Q. on adoption of order relative to sewer connection at premises No. 644
Cambridge St., notwithstanding the objection of his Honor the Mayor.

Order
relative to sewer in
Cambridge Street

Cambridge, Massachusetts,
Office of the City Engineer.
City Hall.

Concerning the matter of a complaint of defective drainage from the building at Nos. 644 to 654 Cambridge Street, southeasterly corner of Parnell Street, owned by Max L. Alpert, I have investigated the matter and find the facts as follows.

Scale 6" = 1"

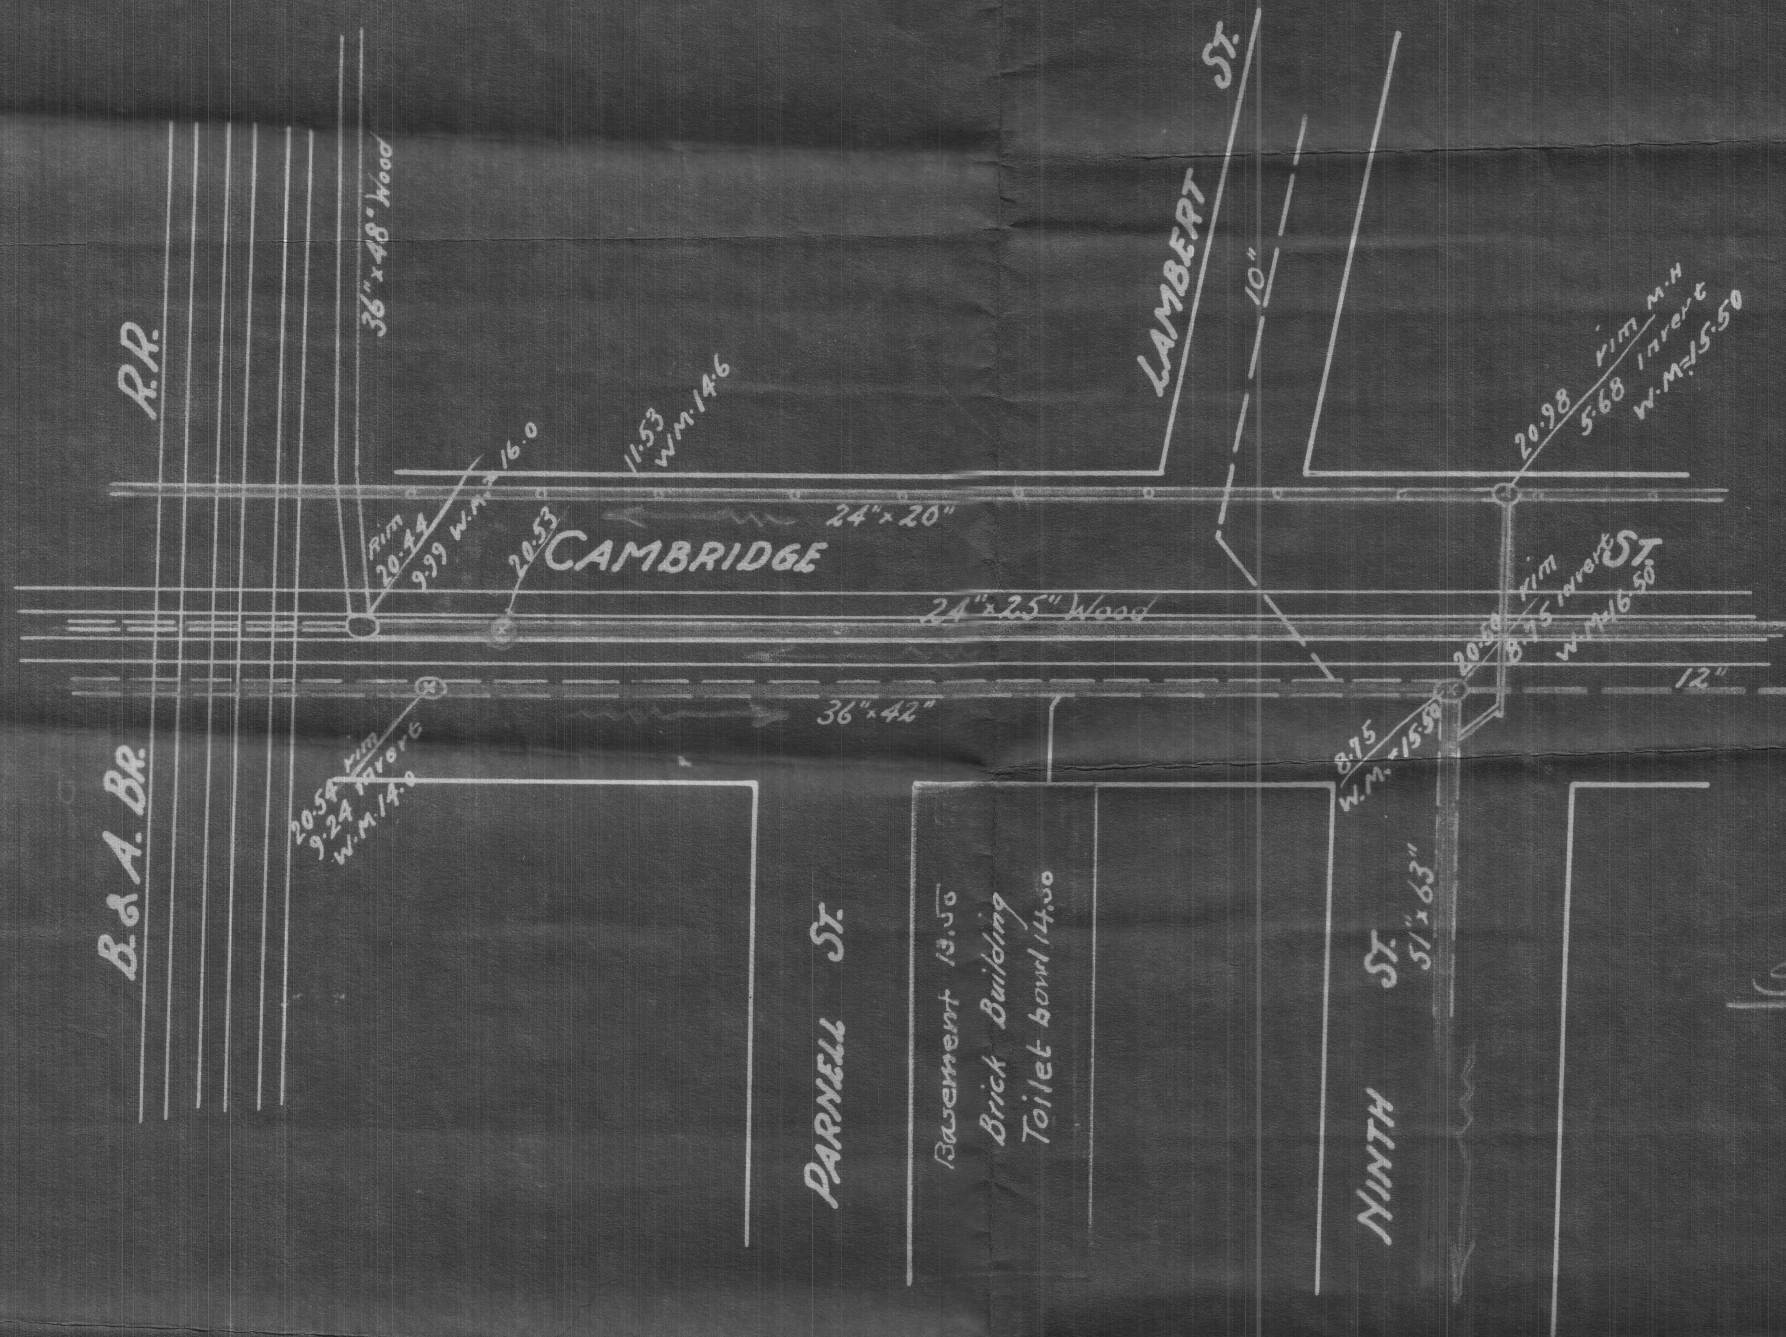
The general situation is shown upon a small accompanying plan. The building is of brick and is used mostly for commercial purposes such as 5 & 10 Cent Store, etc.

The sanitary fixtures, sinks, toilets, lavatories, etc., for the lower part of the building are located on the floor of the basement. This brings the open ends of these fixtures dangerously near the level of the sewers in Cambridge Street, so that in times of heavy rain the water in the sewers rises to a level higher than the level of these fixtures, when of course the water is forced back into the basement.

This is quite clearly shown by the water marks found in the manholes themselves, which are higher than the level of many of the fixtures in the basement. This rise in water level in each of the three (3) sewers shows that they are all affected alike.

It may be asked why the water level in the sanitary sewer in the northerly side of Cambridge Street is so high, if it connects

with the Metropolitan trunk line sewer at Portland Street? The answer is that the Metropolitan sewer in times of heavy rain is itself over loaded with more than their pumps can handle, so that then the two (2) sewer systems are in the same condition. Of course for this the City of Cambridge is not responsible.

I can see no advantage in carrying this private drain pipe across Cambridge Street to the sanitary sewer in the northerly sidewalk, under the conditions as they are at present. In my opinion the only way to get relief is to take all open fixtures from their present low level in the basement and put them on the first or second floor above the danger level of floods. The storm water from the roof should also be kept out of the drain pipe taking the sanitary sewage. This is a matter which the owners of the property should do.

I have consulted the city engineer, who has advised me that the connection requested would not in any way relieve the condition complained of; that in times of heavy rains, etc. the level of the water in the sewer on the northerly side of Cambridge Street rises as high as that of the water in the sewer on the southerly side. This I am advised by the city engineer is the condition on which he bases his conclusion that nothing would be accomplished by the proposed change.
